UNITED STATES ENVIRONMENTAL PROTECTION AGENCY
WASHINGTON, D.C. 20460

MAR 26 2004

R. Paul Detwiler, Acting Manager
Carlsbad Field Office
U.S. Department of Energy
P.O. Box 3090
Carlsbad, New Mexico 88221-3090

In a December 10, 2002, letter from Dr. Triay, the Department of Energy (DOE) requested our approval to dispose of standard waste and compressed waste from the Idaho National Environmental and Engineering Laboratory's (INEEL) Advanced Mixed Waste Treatment Facility (AMWTF) at the Waste Isolation Pilot Plant (WIPP). (Docket A-98-49, Item II-B2-15; all subsequent citations to same docket) We approved the disposal of standard transuranic waste from the AMWTF in a June 2003 letter, and recently approved related waste characterization processes at the facility. (II-B3-56, II-A4-42) Subject to EPA quality assurance and waste characterization inspections, with this letter we now approve disposal of compressed (super-compacted) waste at WIPP with the requirement to place additional magnesium oxide (MgO) with the compressed waste to maintain the current safety factor.

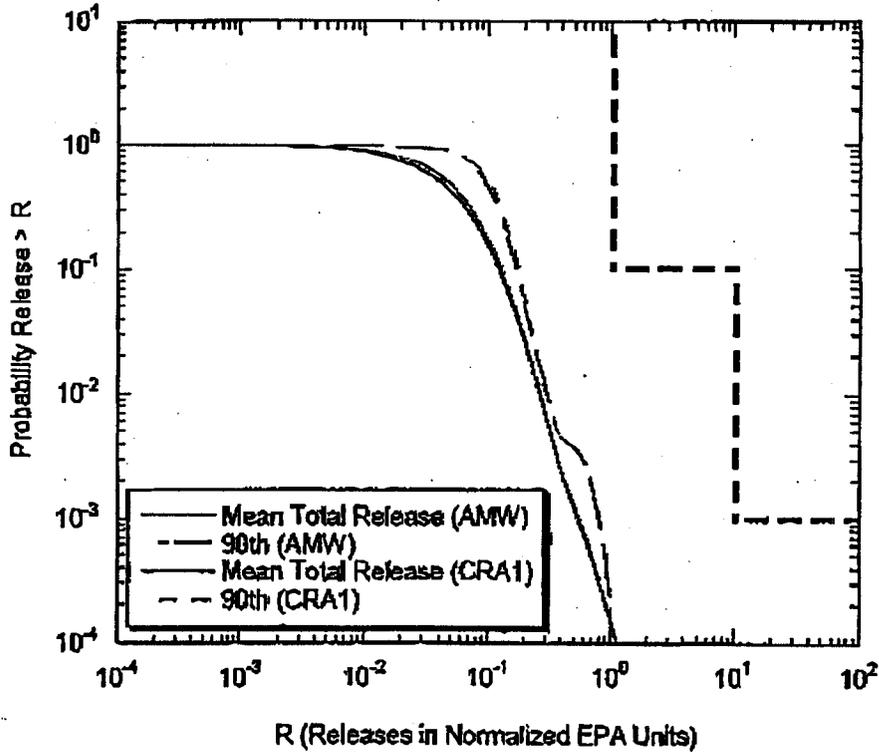
Since the AMW PA inventory and the 2004 CRA use the same inventory, DOE chose to compare the AMW PA with a modified CRA PA¹. In this comparison, the set of CCDF (cumulative complementary distribution function) curves for total normalized releases are almost indistinguishable. The mean total releases and the 90th quantile releases are almost identical. The porosity concerns EPA identified in the review and discussed below should not affect these results because additional analyses showed that important results are not affected by use of constant porosity or porosity surface. EPA's concerns related to the uncertainty are satisfied with a review of the means and 90th quantile of total releases presented in Table 1 and Figure 2.

Figure 5-1. Minimum mass of MgO required per waste package.

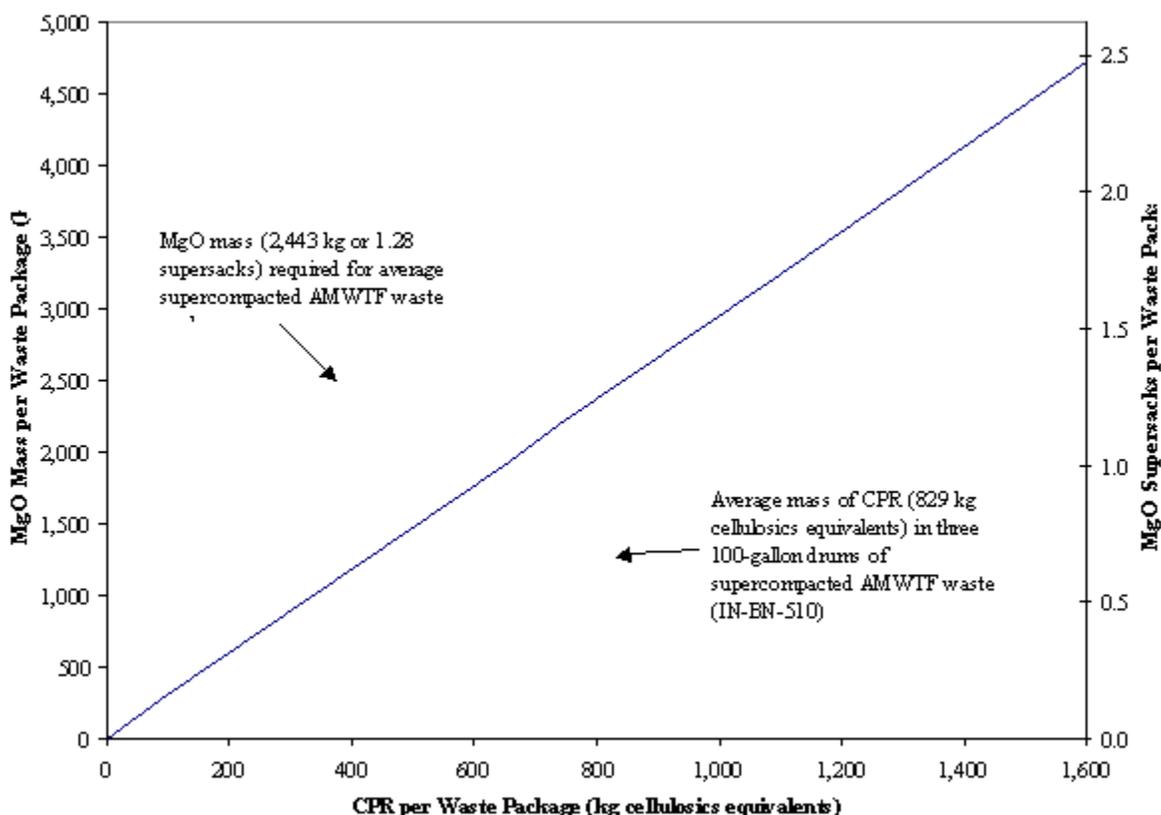
More MgO must be added to the repository than illustrated in Figure 5-1 to allow for the MgO dissolved in brine that may be released from the repository. Such releases can occur through anhydrite interbeds or intrusion boreholes and the MgO removed from the repository would not be available to react with CO₂. The volume of brine that could leave the repository can conservatively be set equal to the volume of brine that could enter the repository. The amount of MgO that would be dissolved in the maximum volume of brine that could enter the repository is 4.81×10^5 kg (Snider, 2003a and 2003b). This would require the placement of an additional 253 MgO supersacks in the repository.
